**City of Lino Lakes  
Environmental Board Meeting**

**September 28, 2016  
6:30 p.m.**

**REQUEST:** Review: Lino Lakes Elementary-Site Plan  
Review/Conditional Use Permit

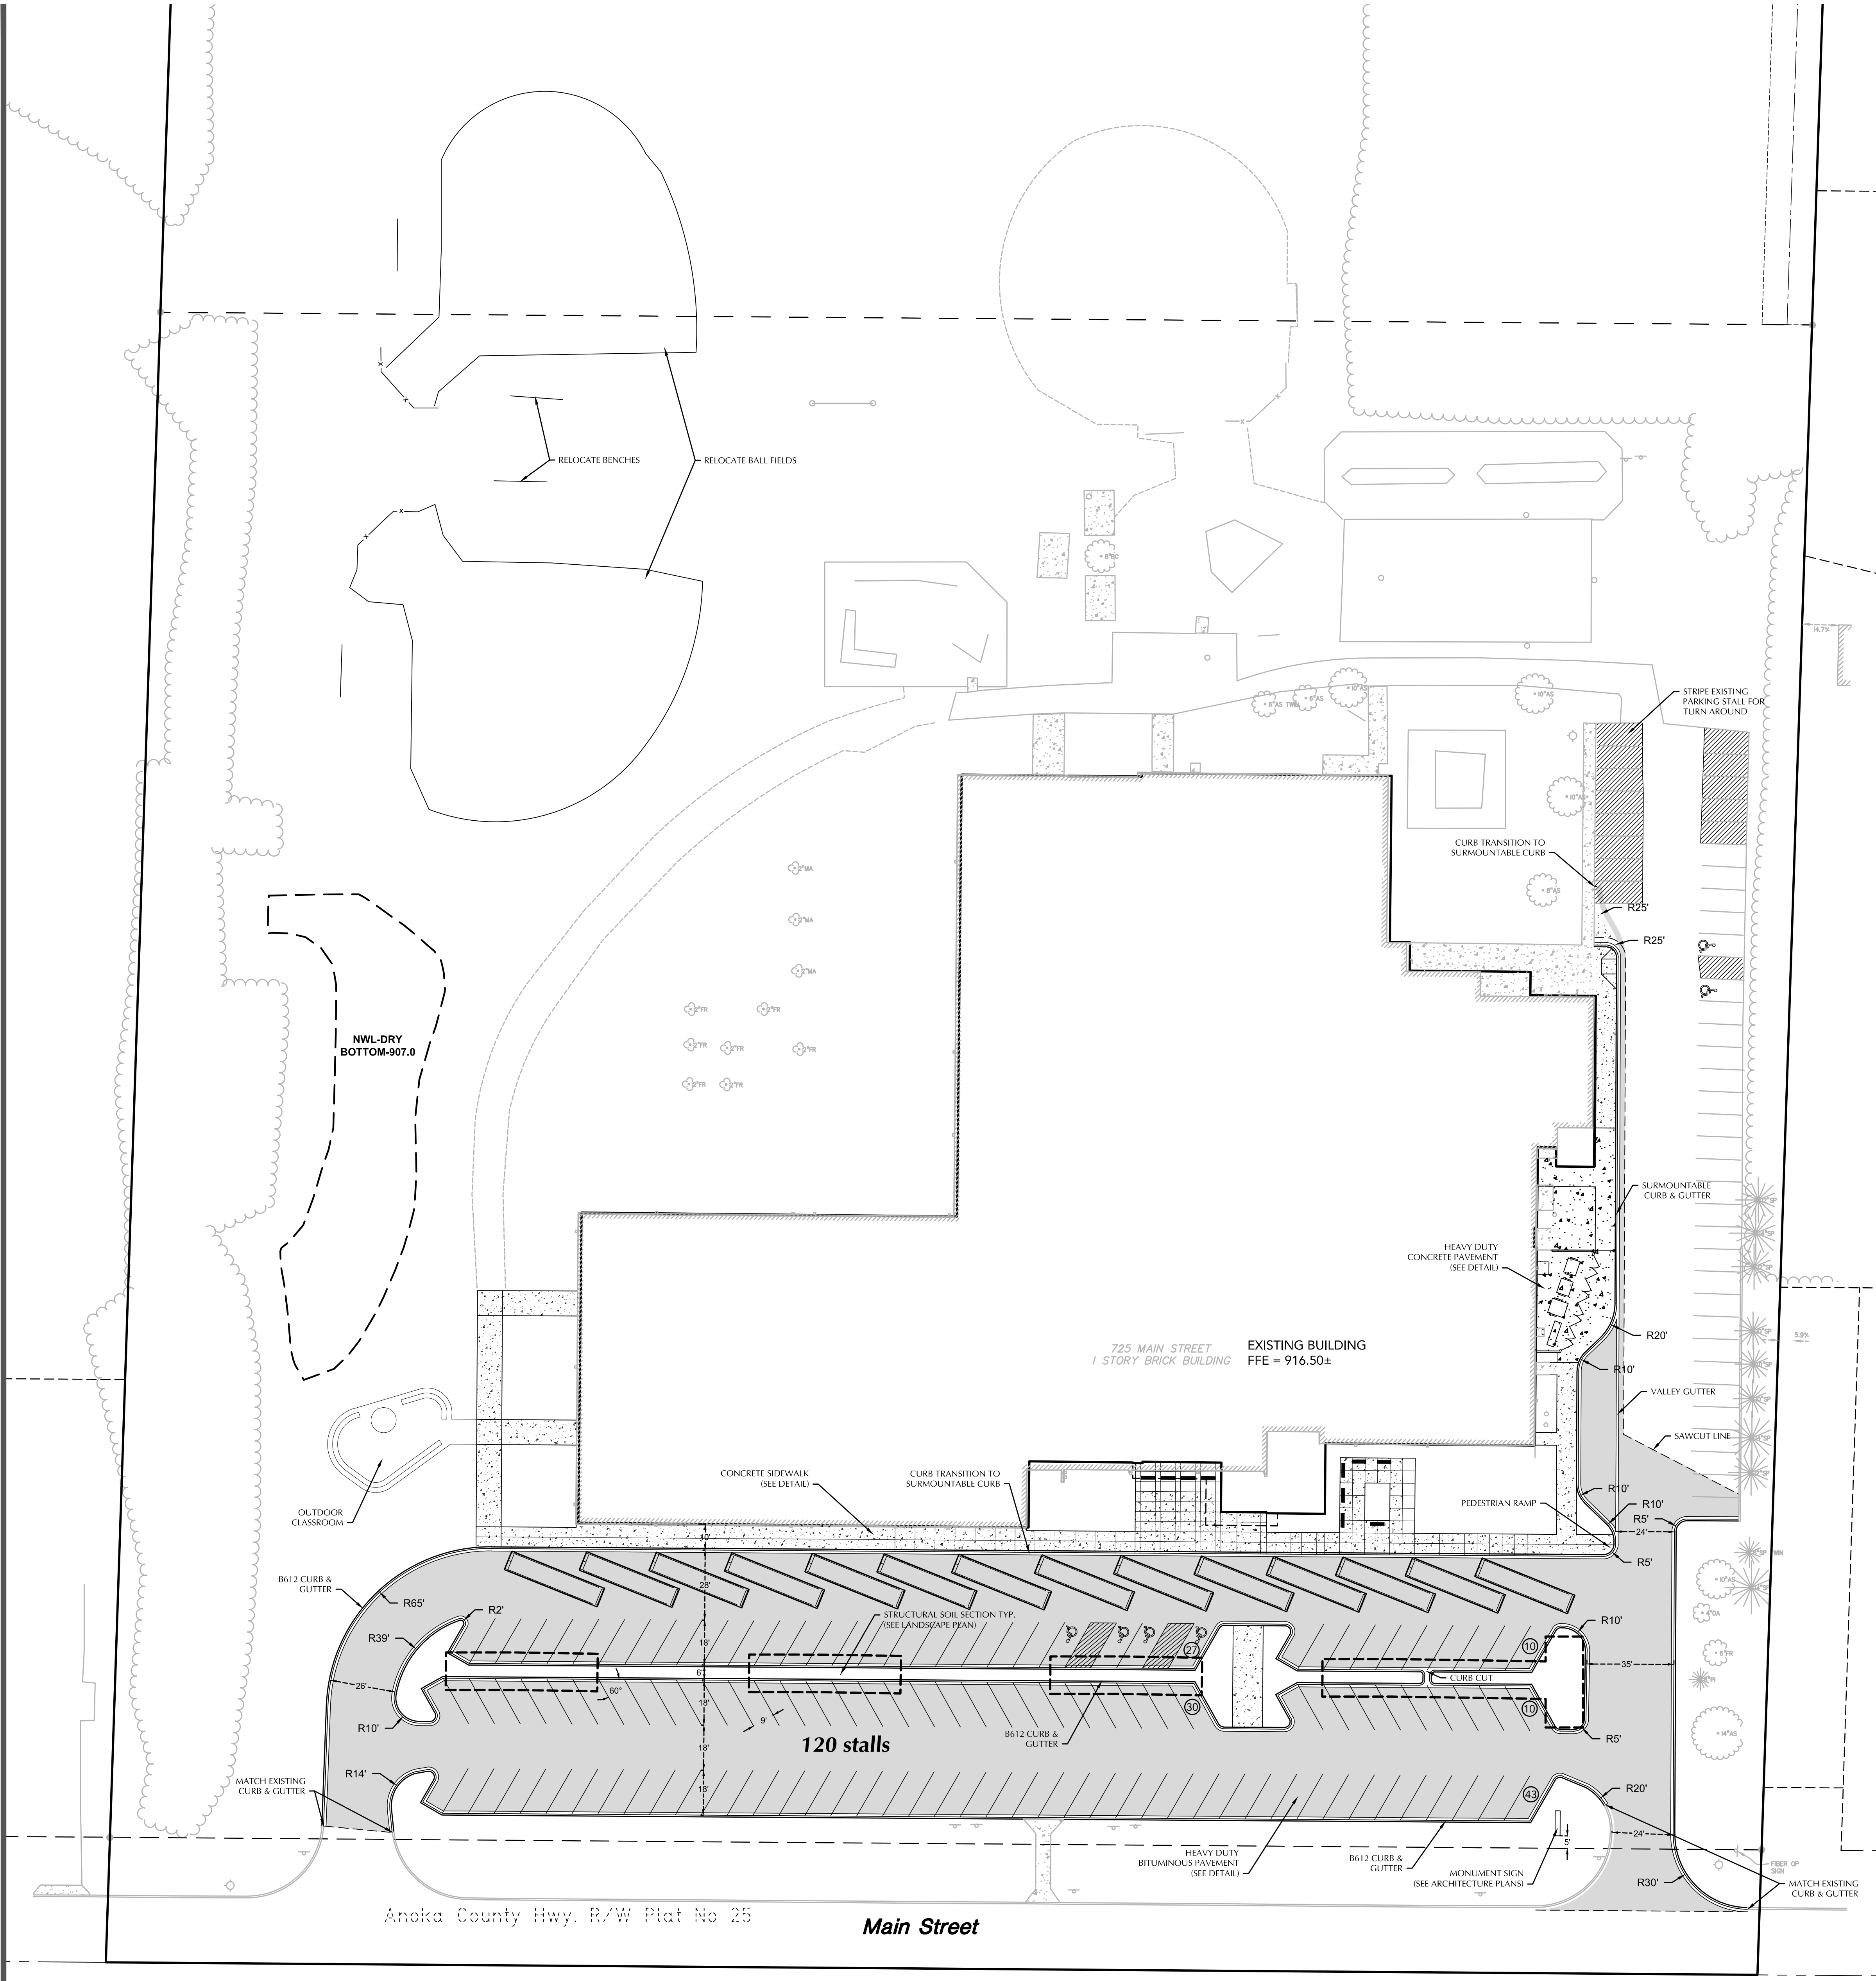
The Site Plan indicates “Relocate ball fields and benches”. The plan should show where these ballfields are moving to.

**GRADING PLAN**

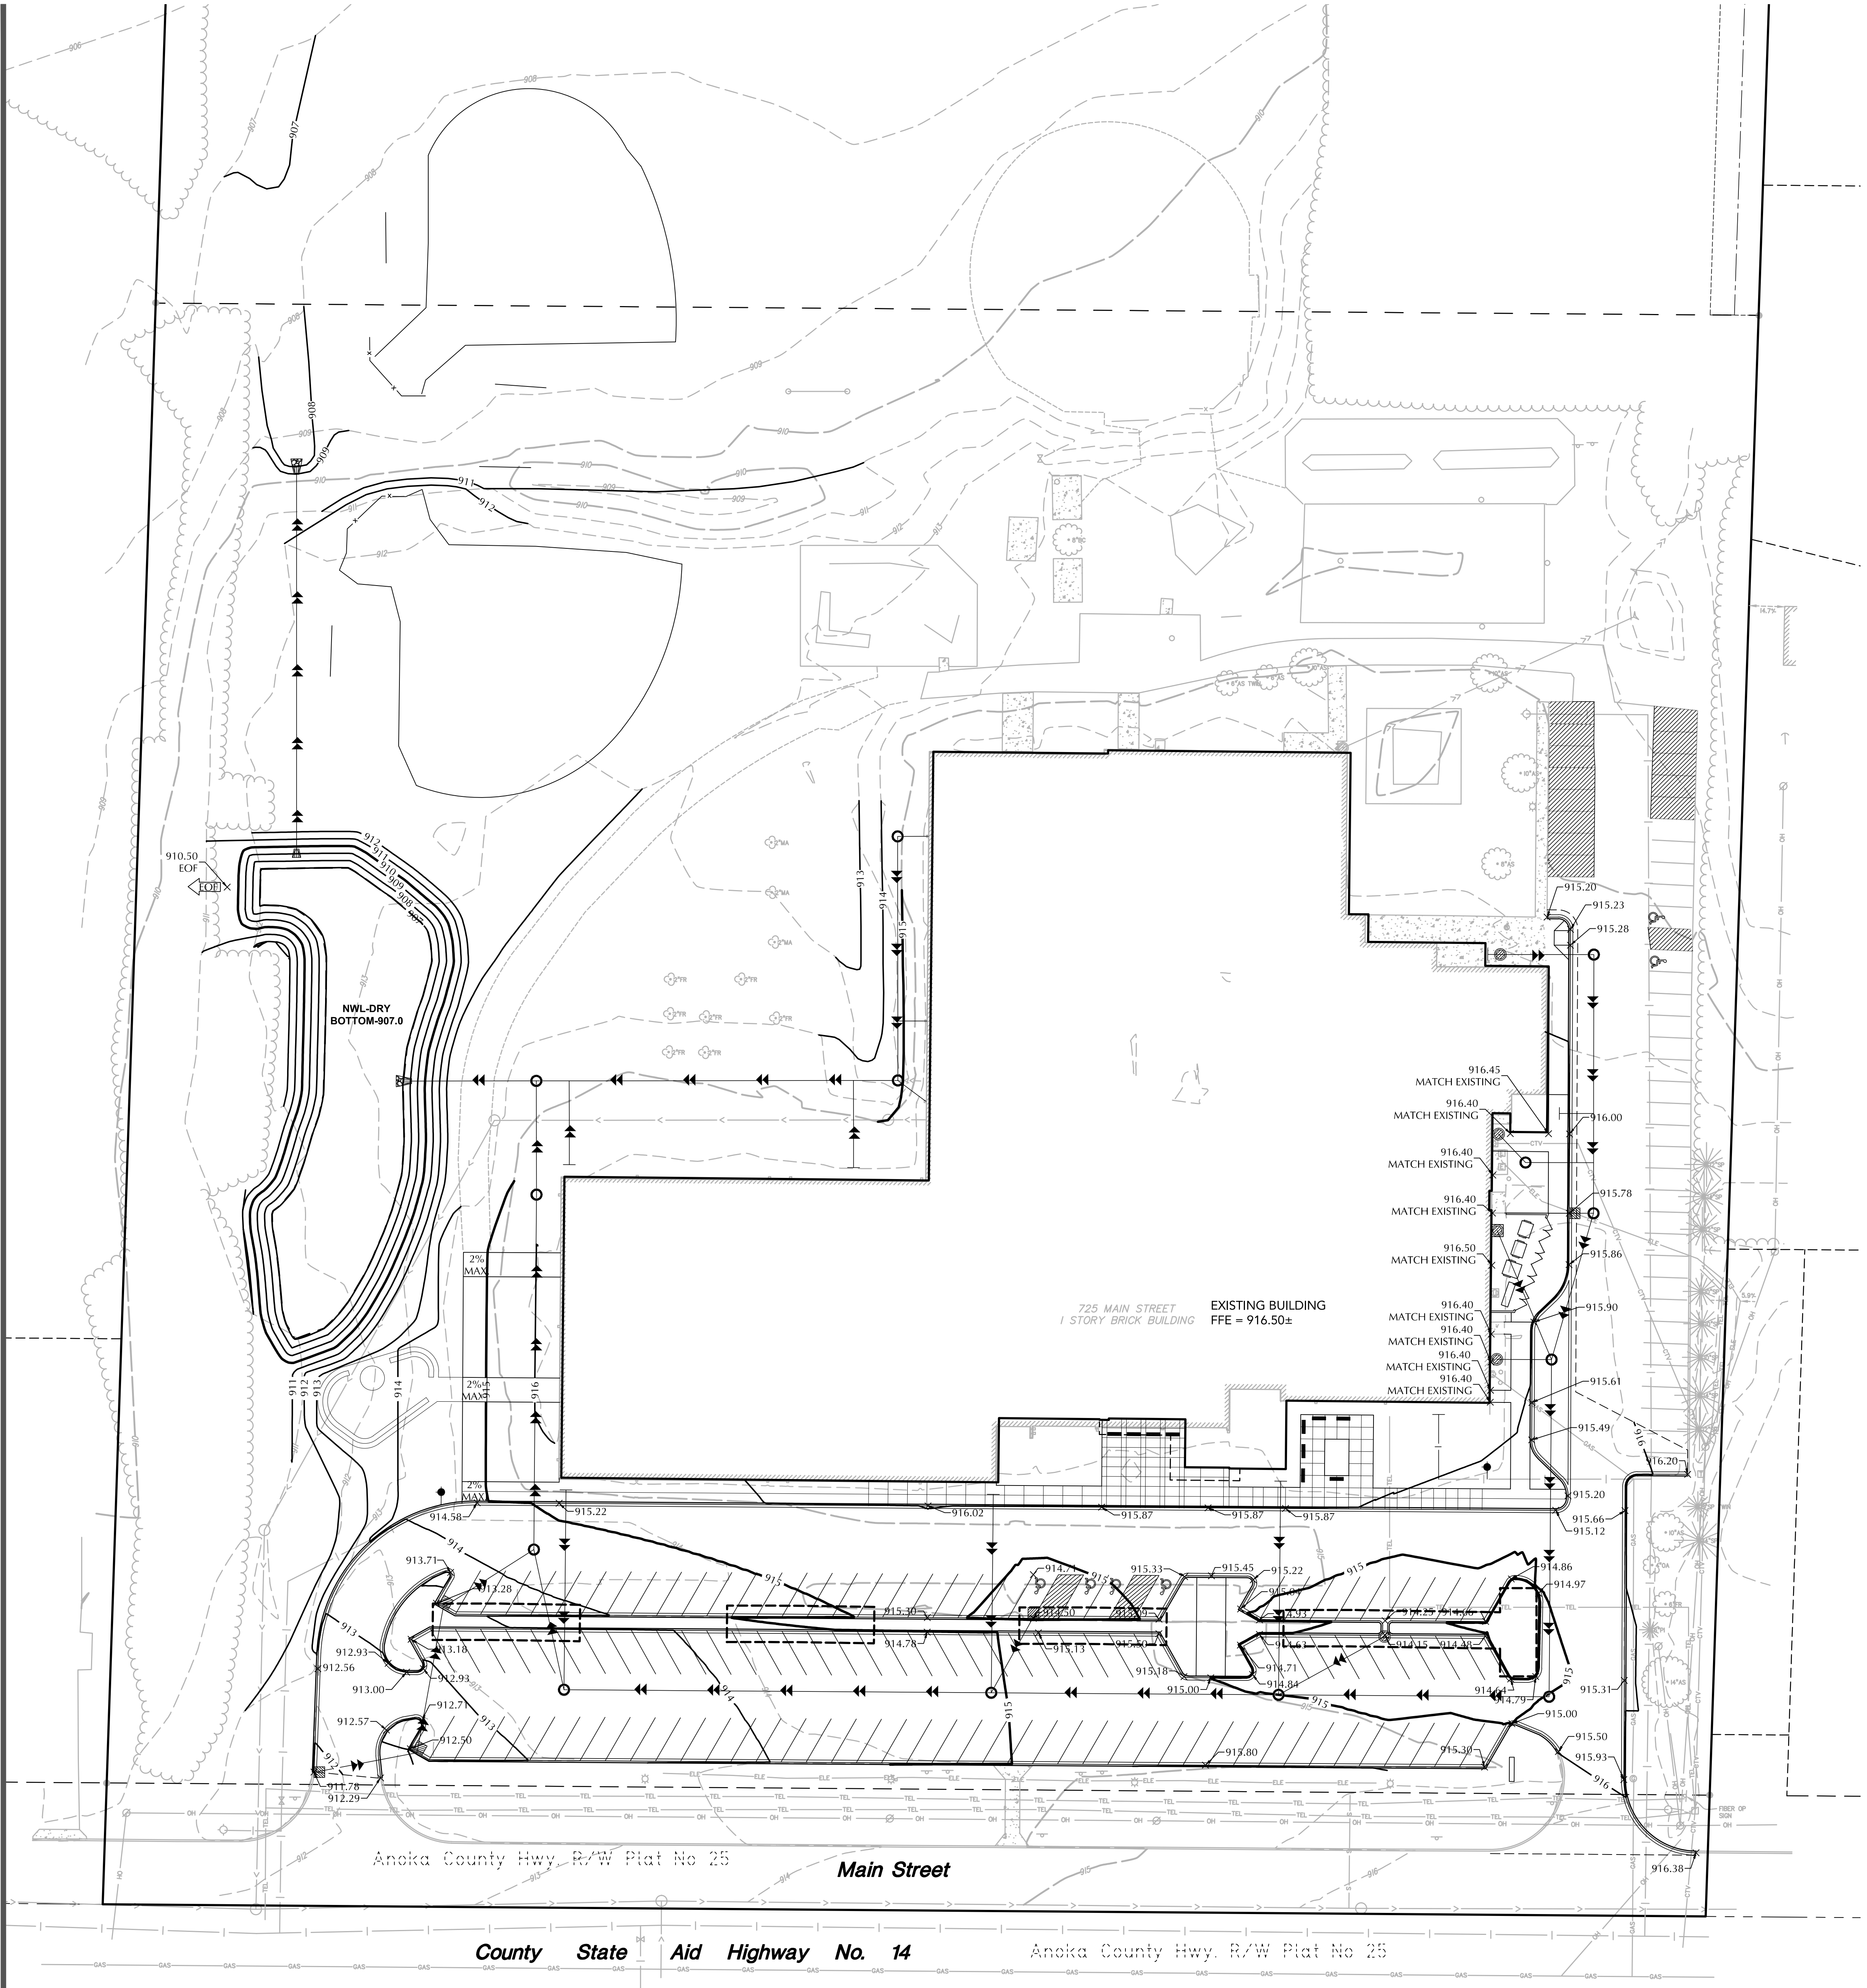
The proposed site contains two drainage areas. One area is the area where the new infiltration pond will be placed. There will be a storm manhole directly upstream of the infiltration basin and will include a 3 foot sump and energy dissipater with skimmer for pretreatment. The other drainage area will sheet flow offsite to the north.

A City storm water grading, erosion and sediment control permit, and a Stormwater Management Plan are required. A RCWD and MPCA permits are also required. No construction shall occur until the requirements of the MPCA permit are in order. A stormwater pollution prevention plan was submitted. A certified stormwater site supervisor must be identified before any ground is disturbed. Weekly and post rainfall event inspections, and follow up correction sheets must be emailed to the City Engineer and the Environmental Coordinator.

Plotted: 09/12/2016 12:25 PM W:\2015\15328A\CADD\DATA\LANDSCAPE.dwg Sheet File#L1-1 Landscape Plan

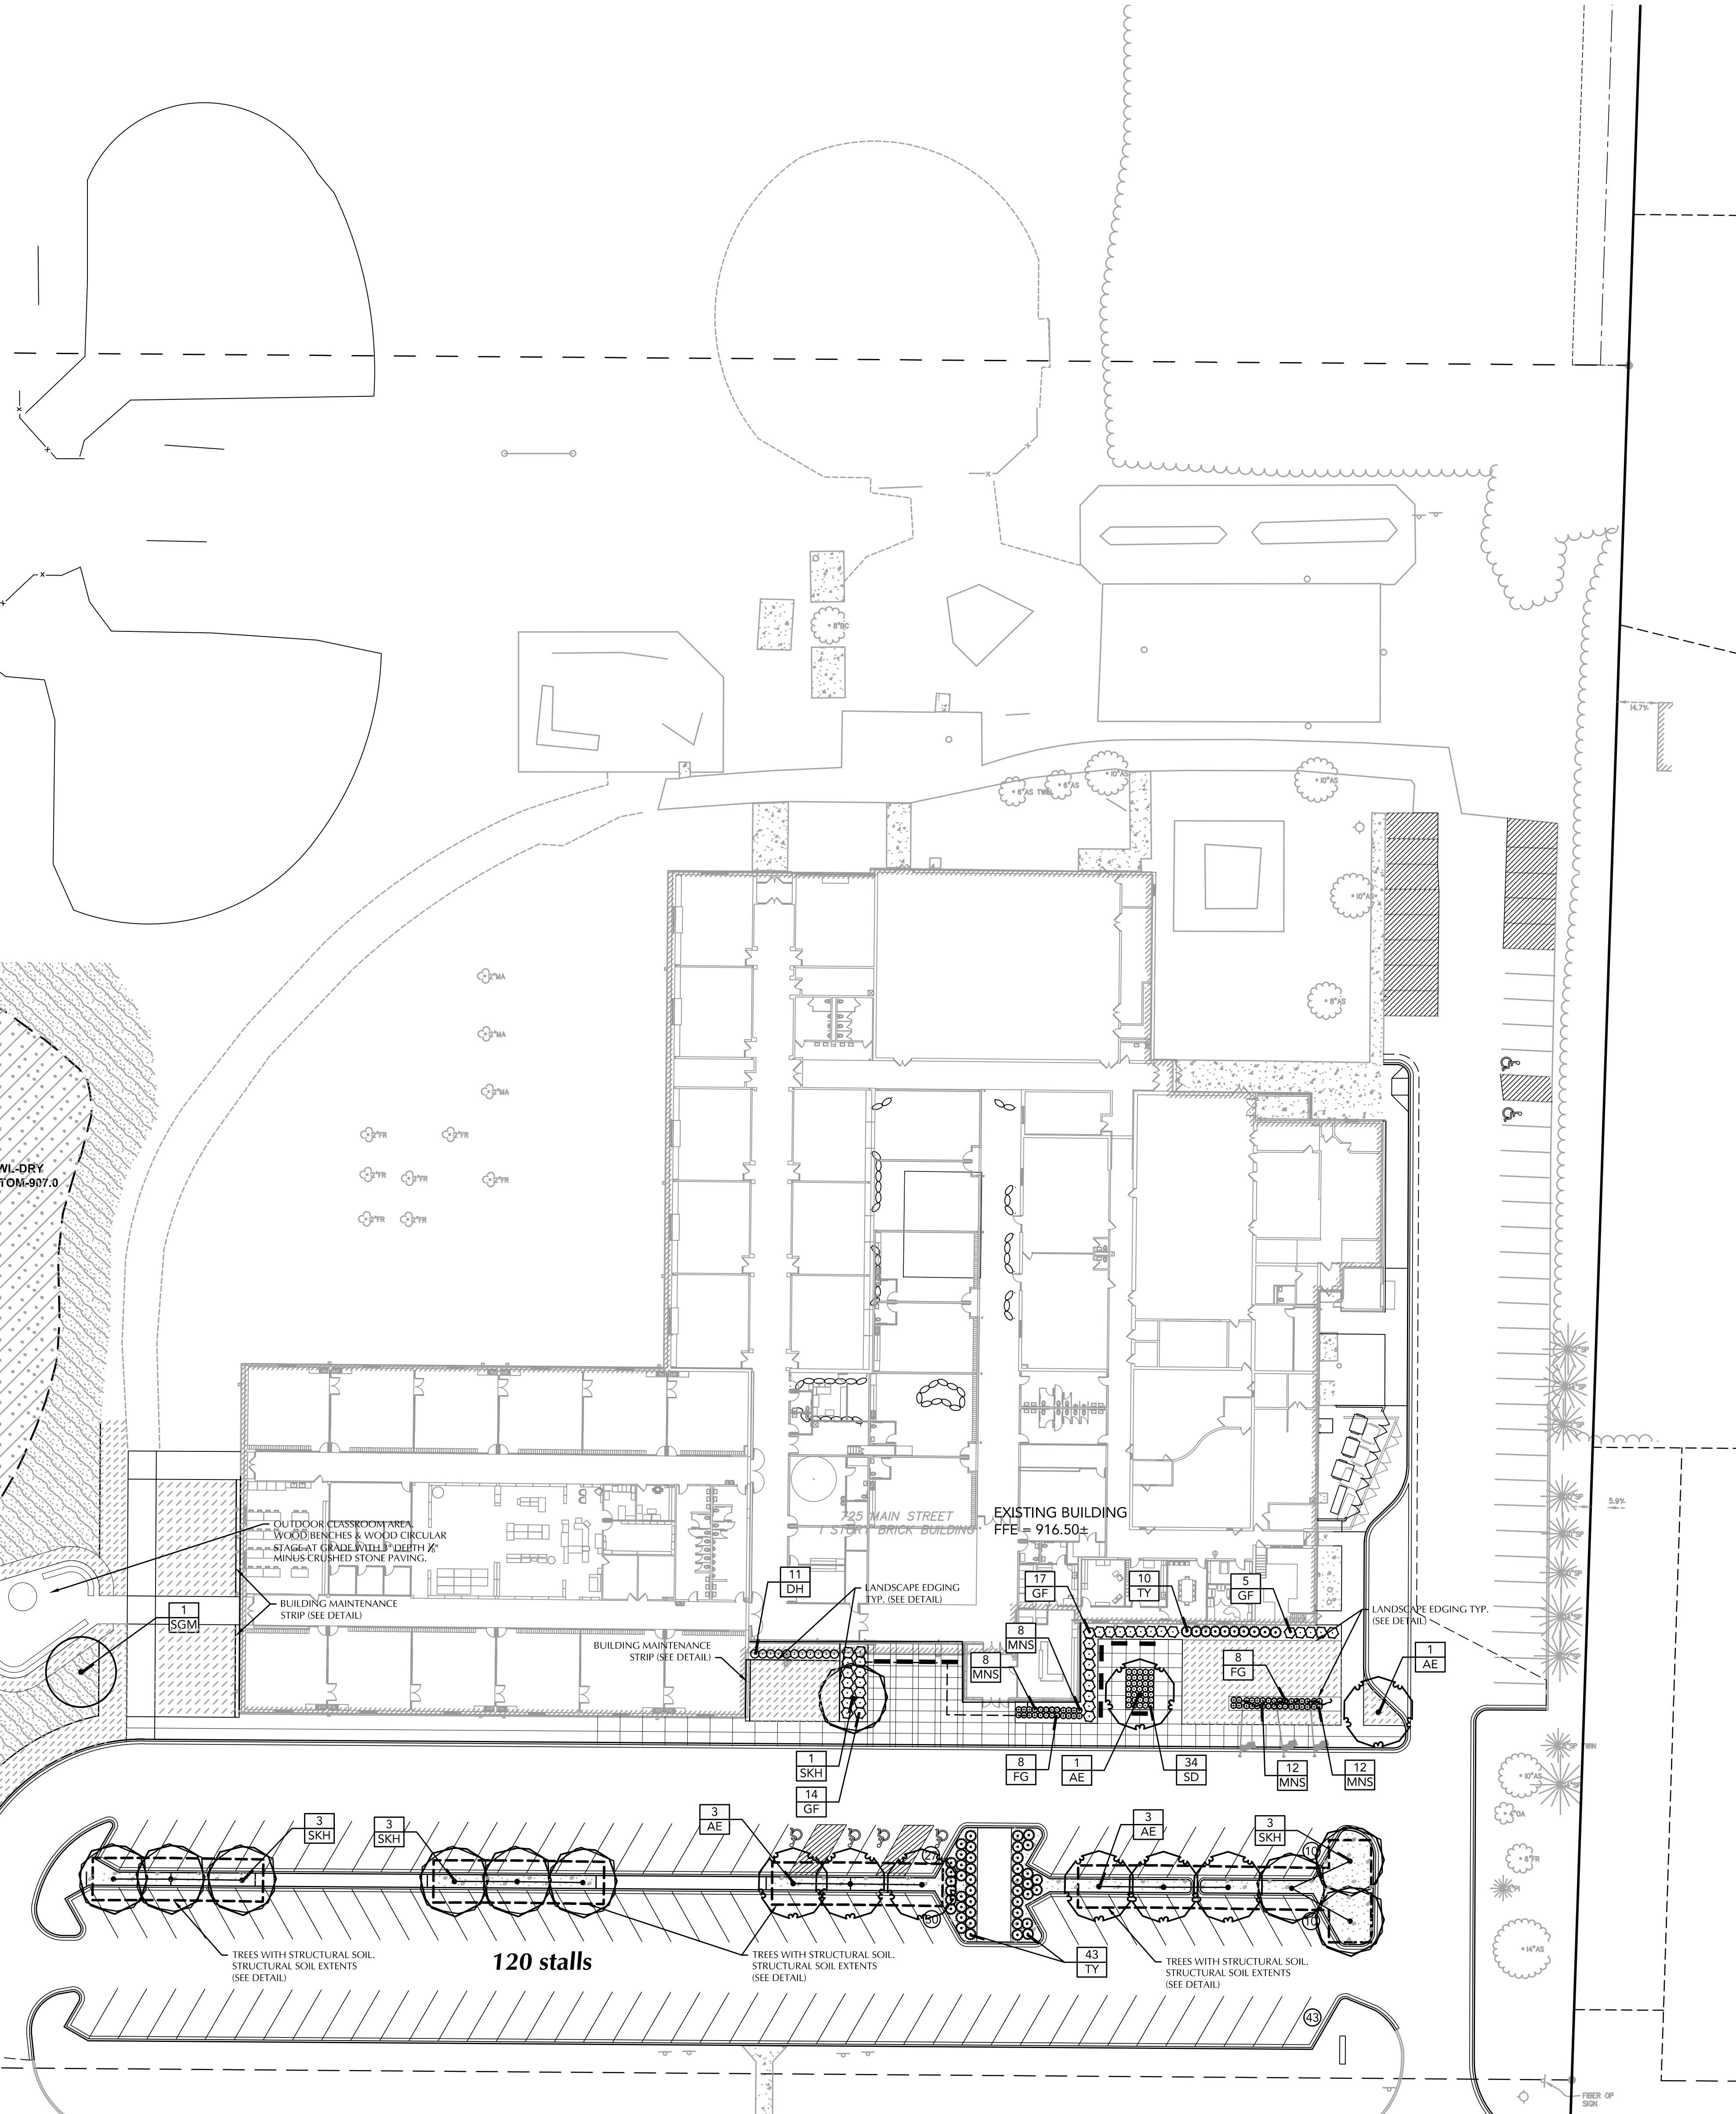
Landscape plan calls out structural soils in the parking lot area. Structural soils need to be supplemented with a drainage, watering, and nutrient delivery system.

Proposed landscape plants (trees and shrubs) are all appropriate plant materials.

Native seed mixes for the pond and upland areas must be approved by the city. Recommend a short native mix for the upland area.
